[Docket No. FAA–2004–18850; Directorate Identifier 2004–SW–19–AD; Amendment 39–14694; AD 2004–16–15 R1]

#### **Airworthiness Directives; Eurocopter France Model AS–365N2, AS 365 N3, EC 155B, EC155B1, SA–365N, N1, and SA–366G1 Helicopters**

**2004–16–15 R1 Eurocopter France:**

**Figure 1**

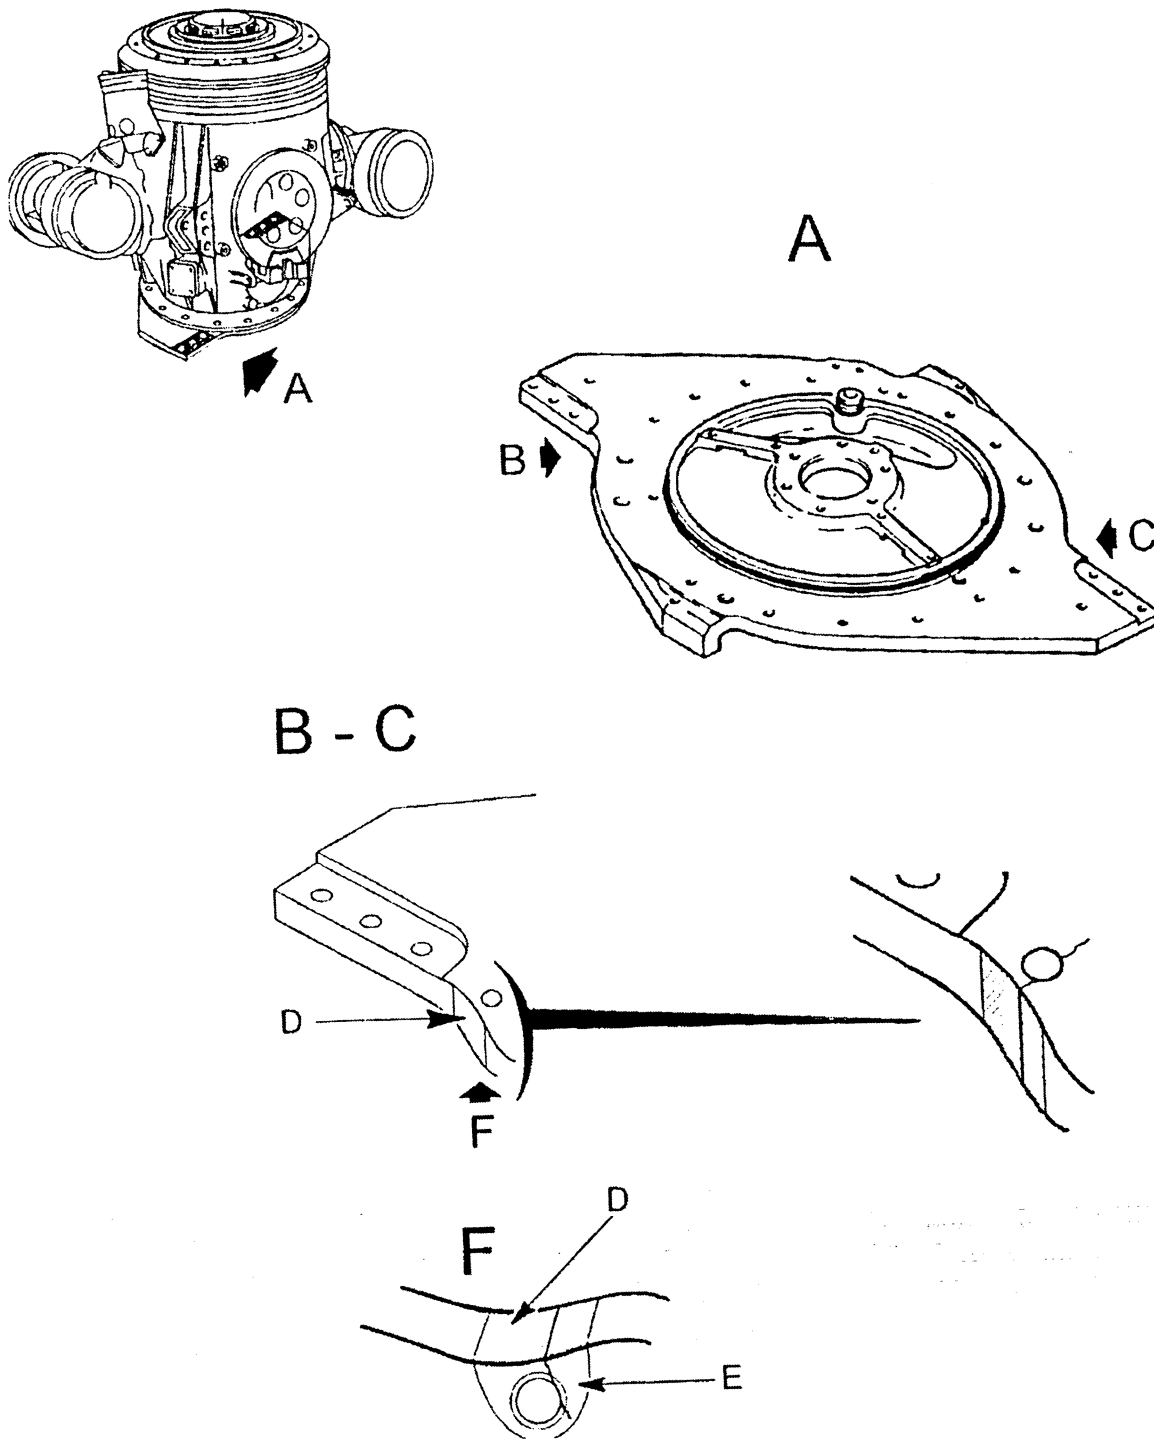
strip the paint from area “D” on both sides (“B” and “C”) of the MGB base plate as depicted in Figure 1 of this AD.

(b) At the times indicated in the compliance table, inspect area "D" of the MGB base plate for a crack using a 10x or higher magnifying glass. Area "D" to be inspected is depicted in Figure 1 of this AD.

(c) If a crack is found in a MGB base plate, remove and replace the MGB with an airworthy MGB before further flight.
